International Building Code 2012 Edition

☐ REVIEWED ☐ REVIEWED AS NOTED
☐ REJECTED ☒ REVISE & RESUBMIT

→ NOTE: ADJUST BUILDING FRAMING
AS REQ'D TO BEAR ON FOUNDATION
PIERS. - SEE MARK-UPS ON
A-BAT PLAN.

DATE	APPROVED	DATE	P.E.	CHK	END	ISSUE	DRG
		8/29/18	JWH	SR		FINANCIAL APPROVAL DRAWINGS	
							 1350 E 37th Street N Wichita, KS 67218 CITY of Wichita, Kansas 2305 E 57th Street South Wichita, KS 67216 A P L L C 101 AIRPORT RD. ST. LOUIS, MO 63129 DAD UP FILE
							JOB NO. 16J0164A REVISION NO. PAGE K1

ANCHOR BOLT PLAN

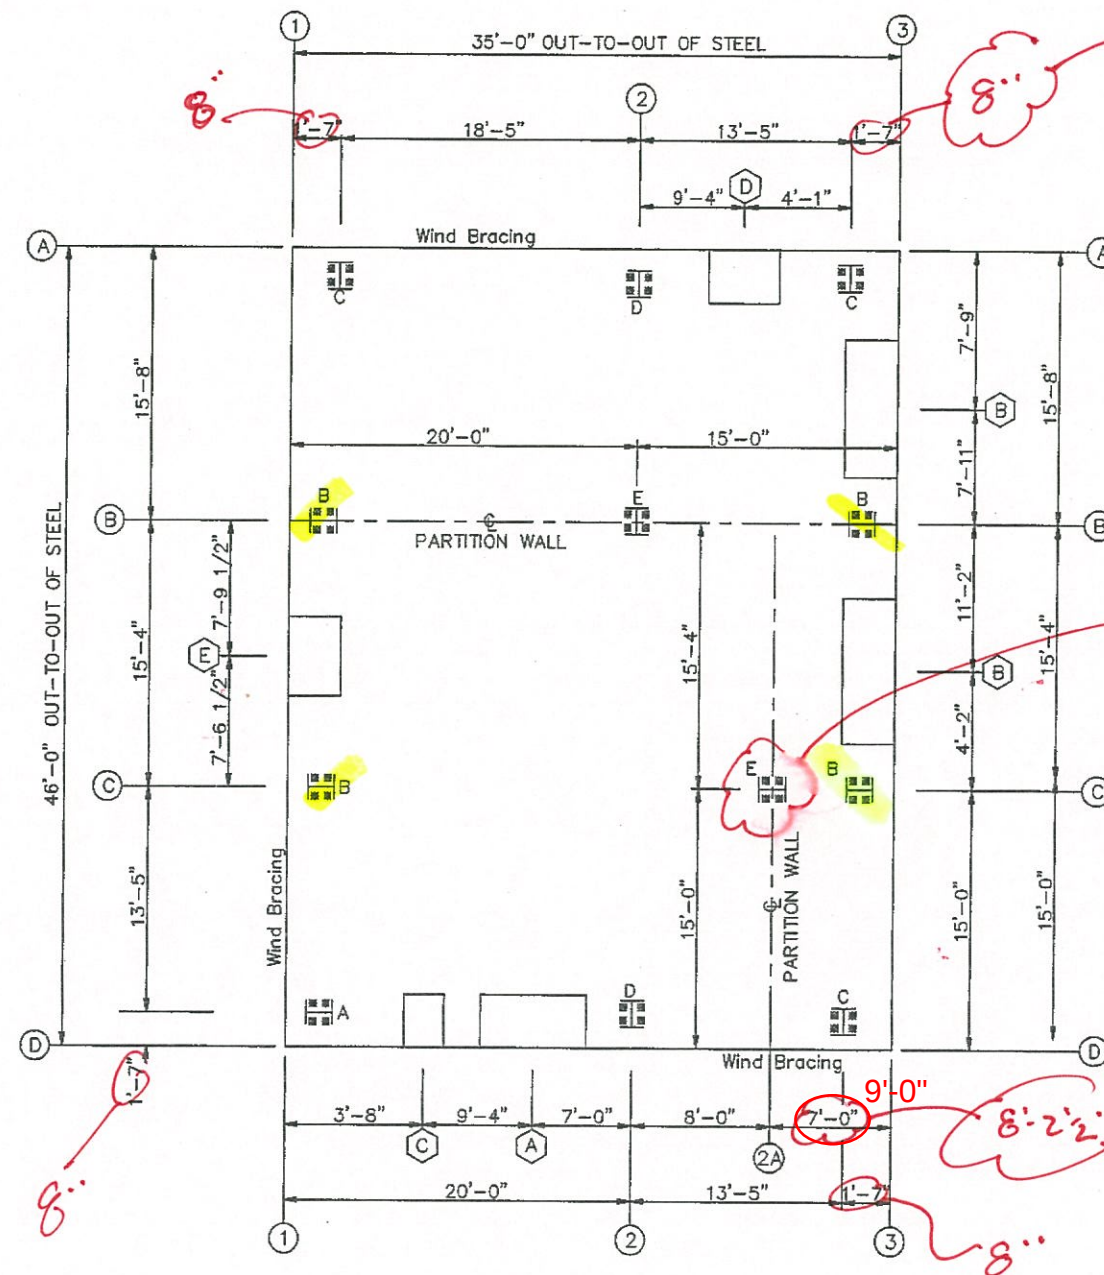
The dimension from Gridline 3 (west edge of building) to Gridline 2A (centerline of partition) should be 9'-0" as marked on the Sheet B1 markup. This dimension was not given on the documents. Structural Engineer suggested 8'-2 1/2" and asked for the Architect to verify. The 9'-0" markup is the Architect's verification.

NOTE: All Base Plates @ 100'-0" (U.N.)
--- Partition Wall (See KeyDwg)

NOTE: 16" SQ. PIER @ CORNERS FOR COL. BEARING. KEEP DIM'S @ 8" TO CENTER COLUMNS ON PIERS.

NOTE: CURRENTLY NO FR. @ THIS LOC. → G.C. PROVIDE PAD FR. @ COL. BEU. LOC.

ARCH VERIFY

ENDWALL FRAMING: FRAME LINE 3

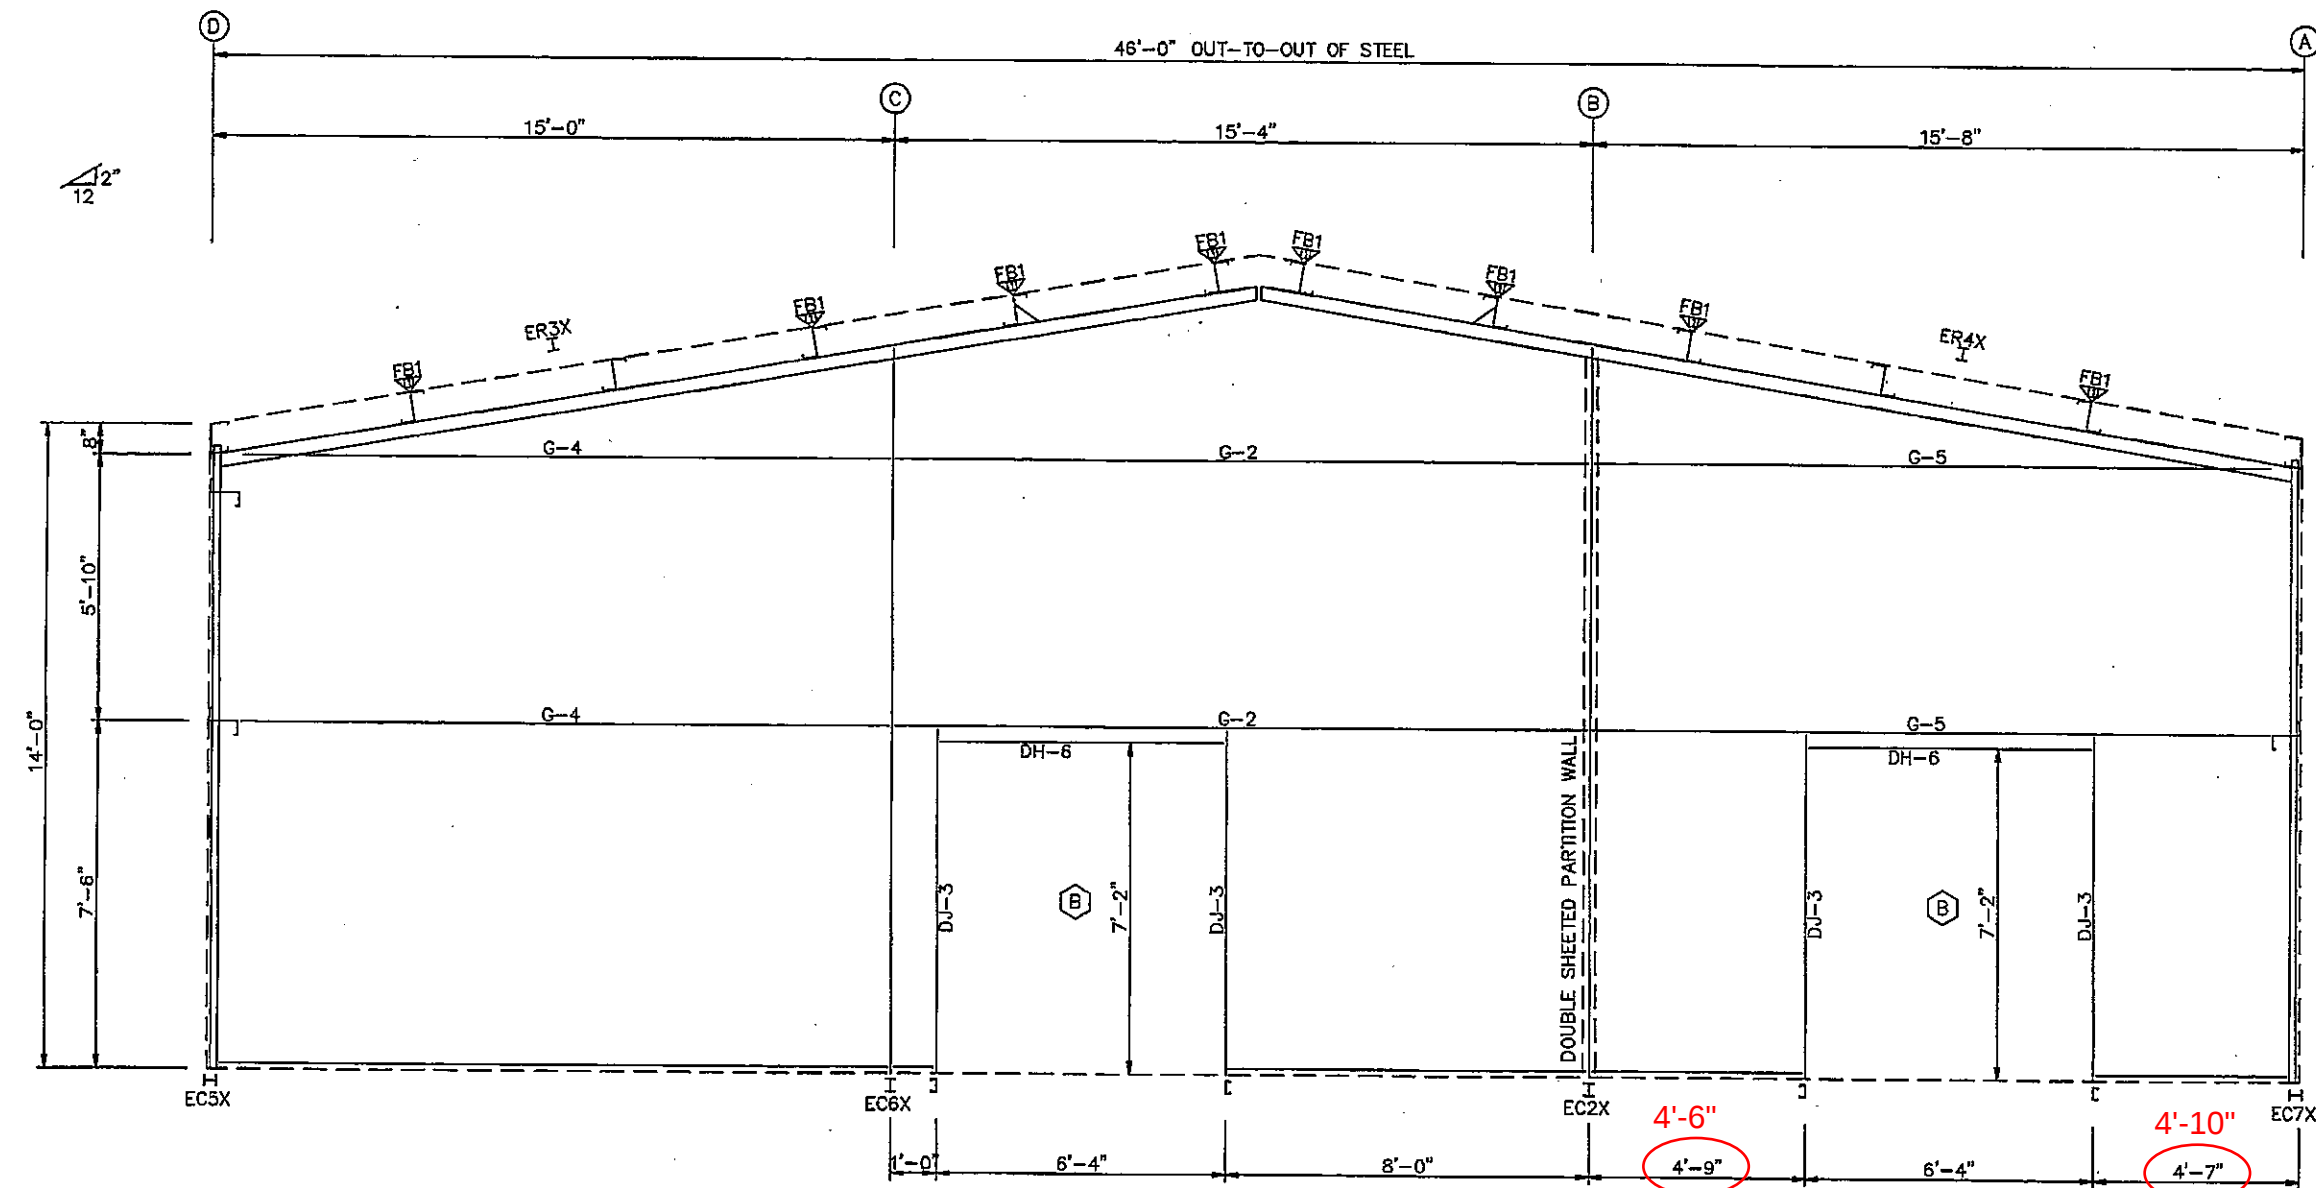
PER RFI-WC-012 Sub-026 Metal Bldg Door Size
